U.S. Department of the Interior
BUREAU OF LAND MANAGEMENT

Well Name: JUSTIS A FED

Notice of Intent

BLM Revised P&A Procedure

Proposed Wellbore Diagram

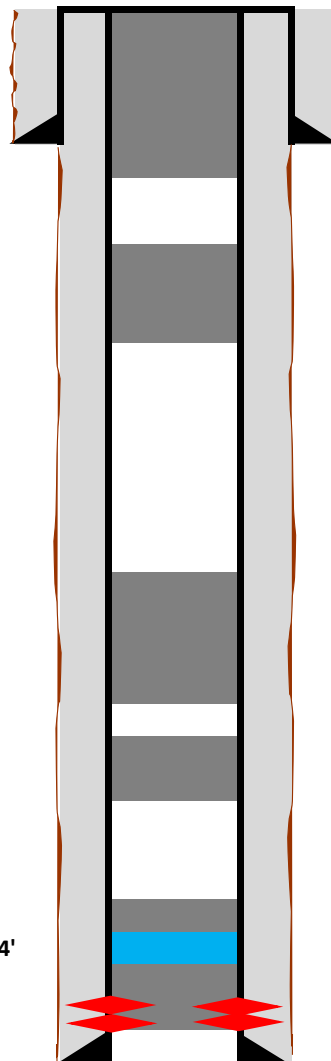
Plug 5
Determine by CBL
1071' to 820'
251 foot plug
24 sacks Type III Cement

Plug 4
Determine by CBL
2440' to 2115'
325 foot plug
31 sacks Type III Cement

Plug 3
Determine by CBL
2660' to 2510'
150 foot plug
15 sacks Type III Cement

Plug 2
Above CR
3034' to 2934'
100 foot plug
10 sacks Type III Cement

Plug 1
SQ Under CR
Top 3034'
20 sacks Type III Cement

Plug 6
Determine by CBL
500' to surface
500 foot plug
48 sacks Type III Cement

11. Plug 1: Sqz below the CR from 3238' to 3034'.
12. Plug 2: Spot Cl C cmt from 3034'to 2764'. **WOC and Tag. (T/ Queen)**
13. Plug 3: Spot Cl C cmt from 2700'-2500'. **(T/7 Rivers)**

14. Plug 4: Spot 31 sx Cl C cmt from 2440'- 2115'. **WOC and Tag (T/Yates, T/Base Salt)**
15. Plug 5: Spot 25 sx from 1071' -820'. **WOC and Tag (T/Salado and Rustler)**

16. Plug 6: **Surface Casing Shoe, 500'-Surface, 48 Sacks Type III Cement**
17. Cut Wellhead and install Dry Hole Marker.
